MIL-C-63358(AR)
AMENDMENT 1
31 August 1993

MILITARY SPECIFICATION

CIRCUIT CARD ASSEMBLY: 11834811, OUTPUT

FIGURE 4. Temperature cycling.

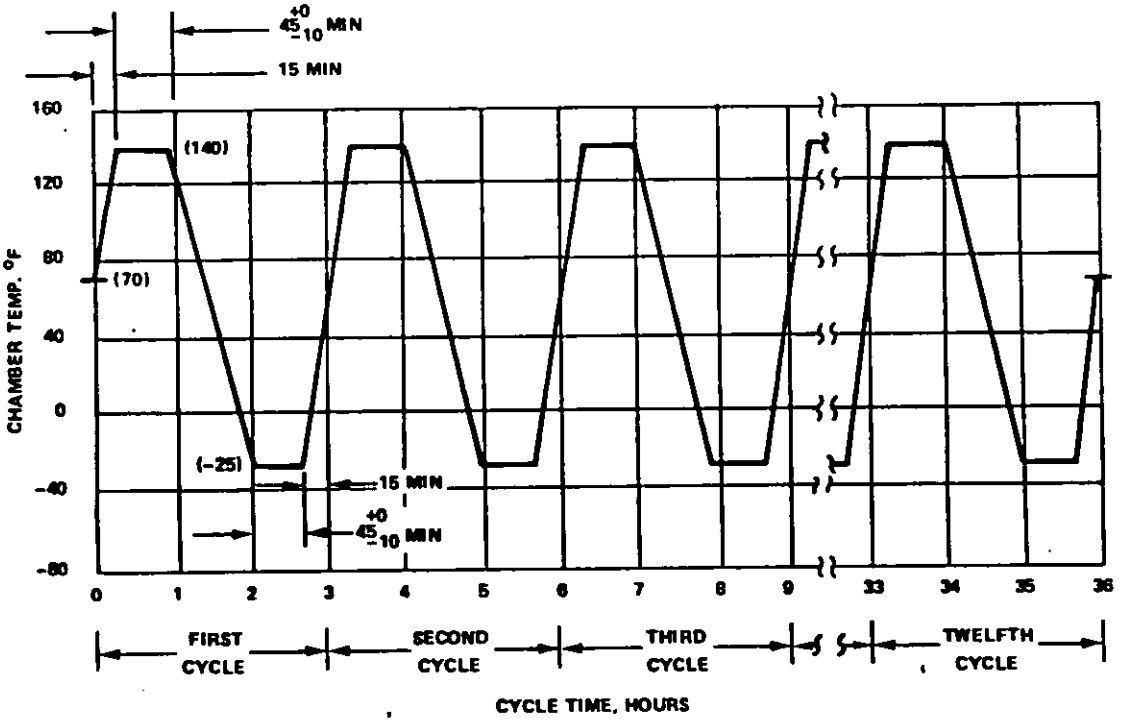
Figure 5: Delete figure 5 in its entirety and substitute the following:

4.6.4.5, line 2: Delete "...figure 5..." and substitute "...figure 4...".
